Modular units for machine tool construction — Multi-spindle heads — Casing and input drive shaft dimensions

AMENDMENT 1

Amendment 1 to International Standard ISO 2912-1973 was developed by Technical Committee ISO/TC 39, *Machine-tools*. It was submitted directly to ISO Council, in accordance with clause 5.10.1 of Part 1 of the Directives for the technical work of ISO.

Figure 2 — Input drive shaft

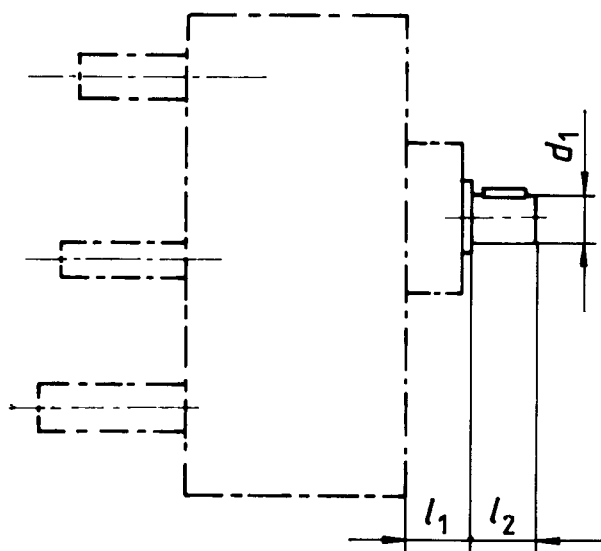
Figure 2; and table 2.

Delete the existing figure and table and substitute the following.

Table 2 — Dimensions of input drive shaft

d_1	tol.	l_1^*	l_2
28	j6	40	60
38	k6	50	70
42	k6	65	70
48	k6	80	85
60	m6	100	110

* Mounting dimension given for information only.
